City of Evansville  
**Park & Recreation Board Regular Meeting**  
Tuesday, December 21<sup>st</sup>, 2021, 6:00 p.m.

# Evansville West Side Park and Leonard-Leota Park Improvements

Project Process Report | December 13, 2021

**WEST SIDE PARK - CONCEPT PLAN**  
 EVANSVILLE, WI - December 13th, 2021

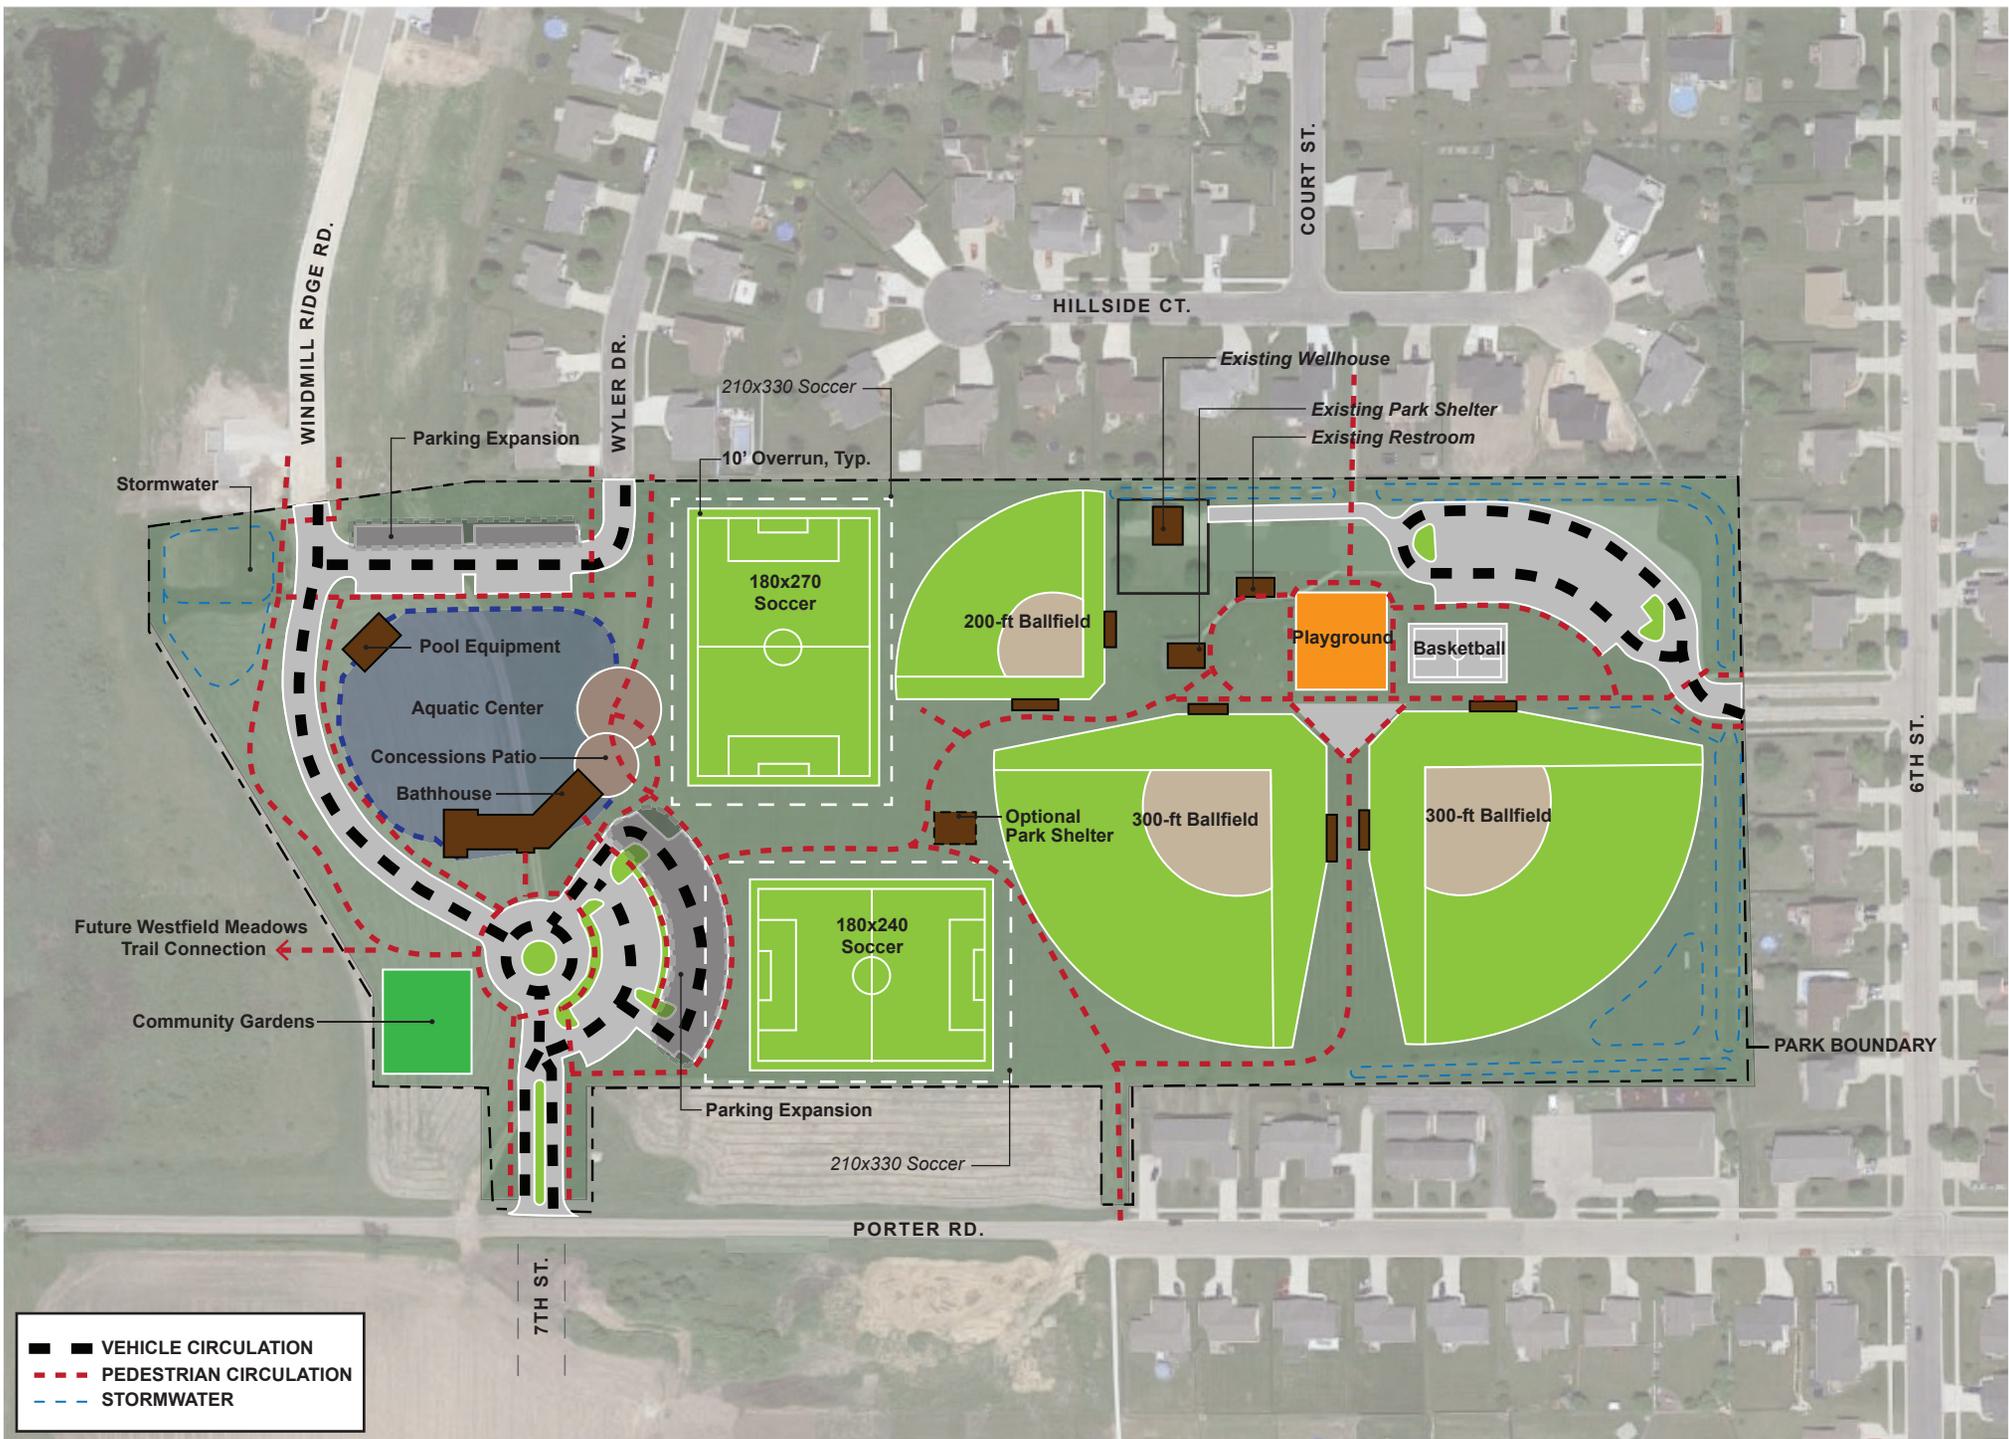
A Public Comment period was held through November 14<sup>th</sup>. Responses identified a number of proposed ideas and changes to the initial concepts to fit the needs of project stakeholders better. A total of 182 comments were received – via the Survey Form or direct emails. Primary takeaways from community feedback:

The Design Team (MSA, WTI, and Rettler) developed updated concepts to address the feedback received from the community as well as the City's project team.

Aquatic Center – Option 3 was updated to show alternate arrangements of the diving well and lap pool to develop flexibility in lap swim and pool availability. Overall site modifications included a revision to the landscape areas and site amenities.

**WEST SIDE PARK - REFERENDUM FIELD CONFIGURATION**  
 EVANSVILLE, WI - December 13th, 2021

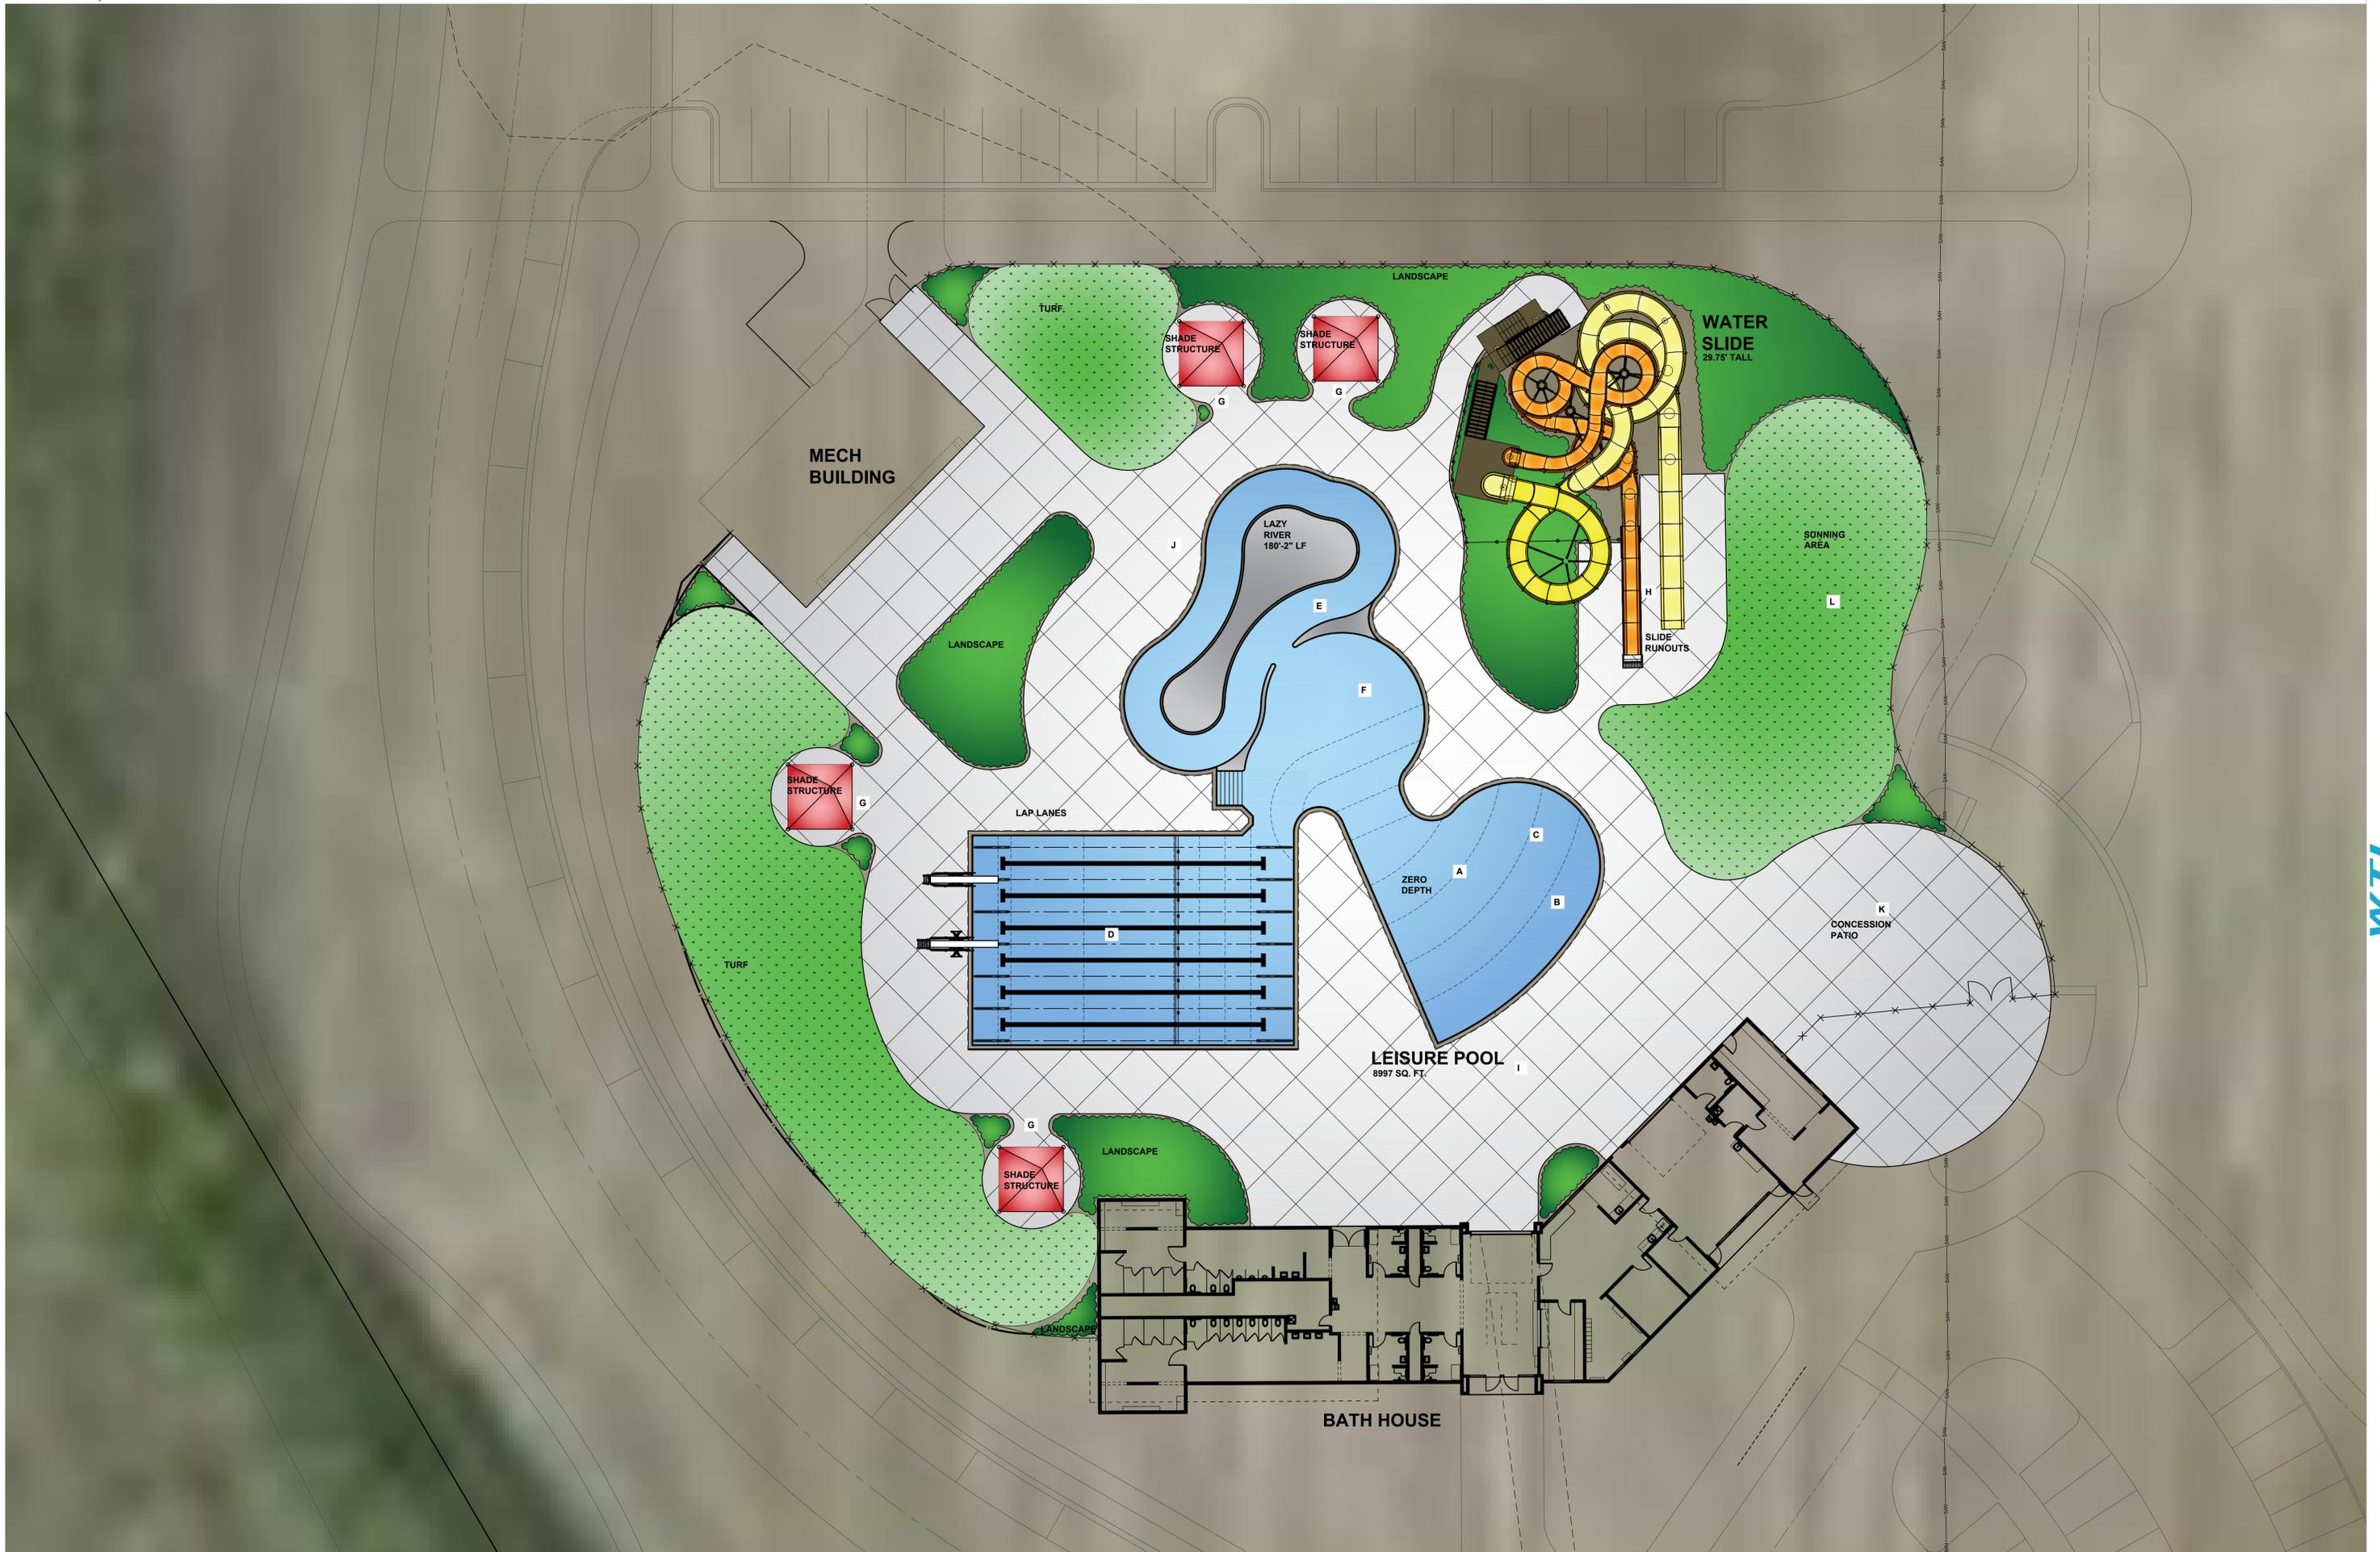
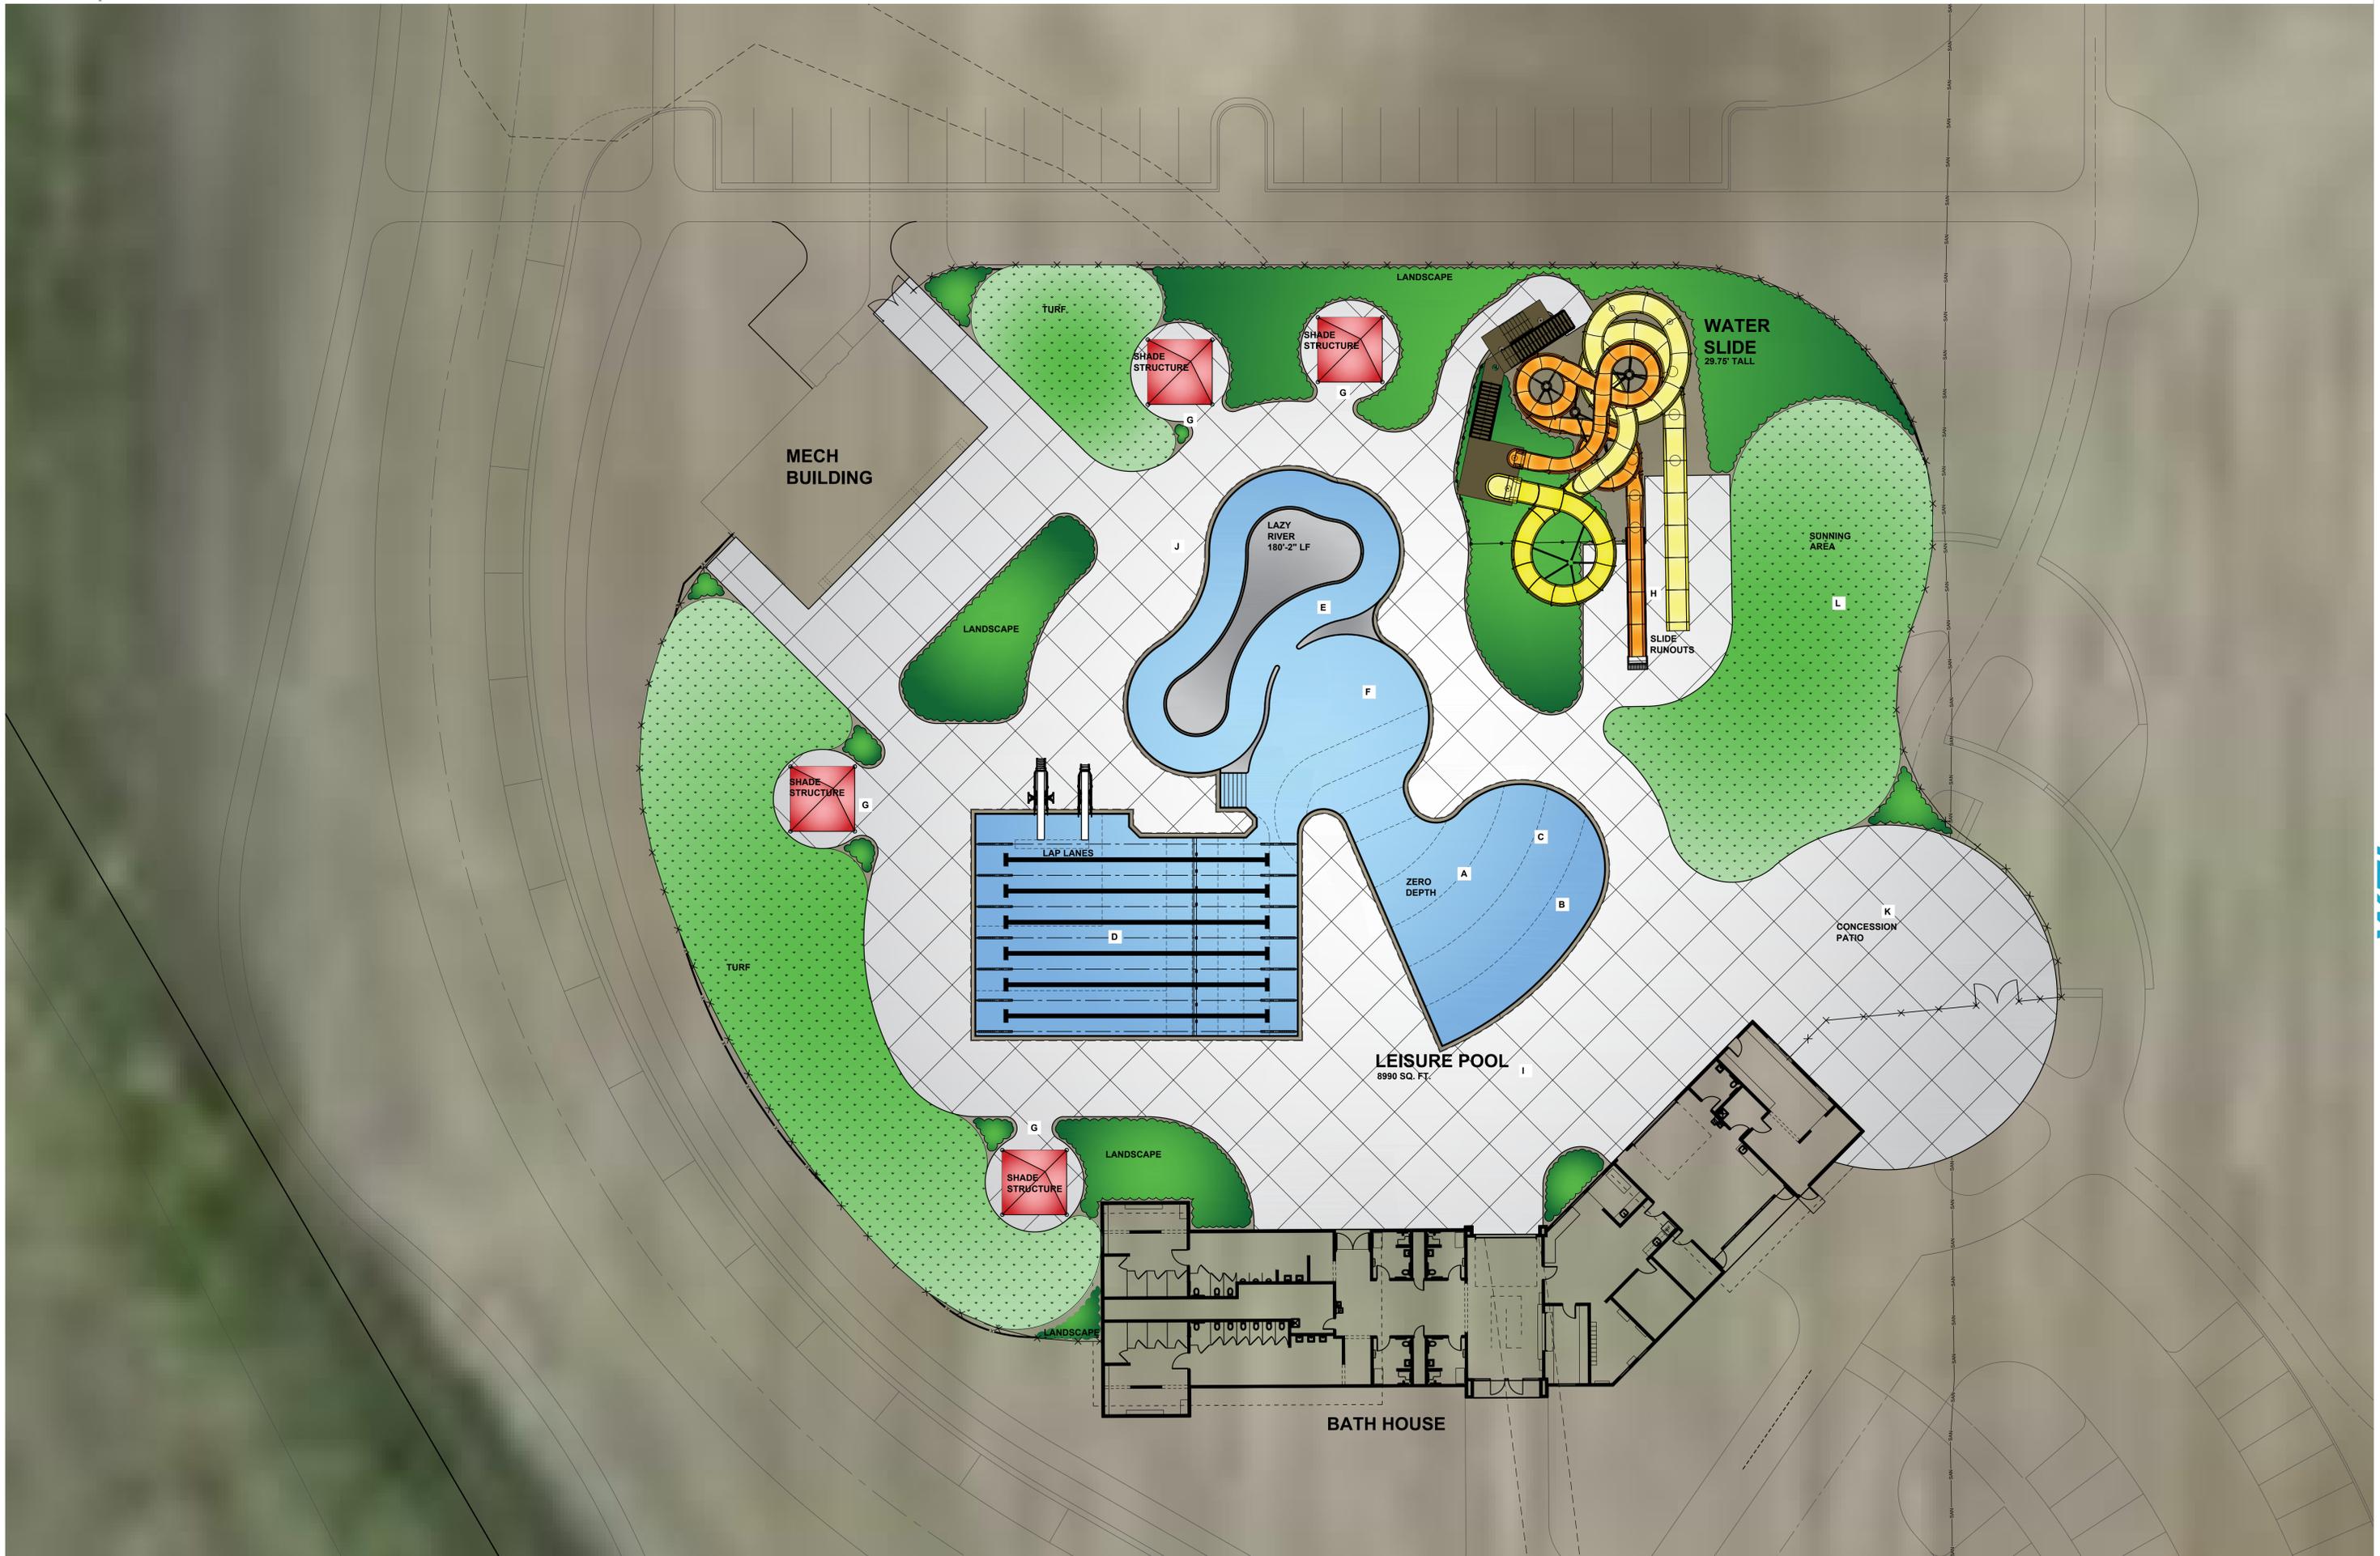
- West Side Park - Concepts did not include the proper mix of athletic fields – the field layout shown is not sustainable for soccer in Evansville.
- Aquatic Center - Option 3 was preferred, emphasizing open water play and the lap pool.
- Leonard-Leota Park - Option C was preferred. The splash pad is closer to the rest of the park (elevation) & integrates it into the park better. The tiered design of the splash pad in C takes advantage of the sloped site, could look more "natural" to blend with the beauty of the rest of the park.
- Future project communication should discuss accessibility, the general character of the park(s), landscaping.

West Side Park - The revised concept shows two full-sized soccer fields, a 300-ft ballfield and a 200-ft softball field. An additional backstop is provided for practice and recreation play. A second 200-ft field was omitted from the concept to maintain additional unprogrammed open space and equity in the dispersion of resources between baseball/softball and soccer. A different concept was developed that shows an updated view of the referendum plan, note due to spatial constraints, sizes of the fields were reduced in this concept.
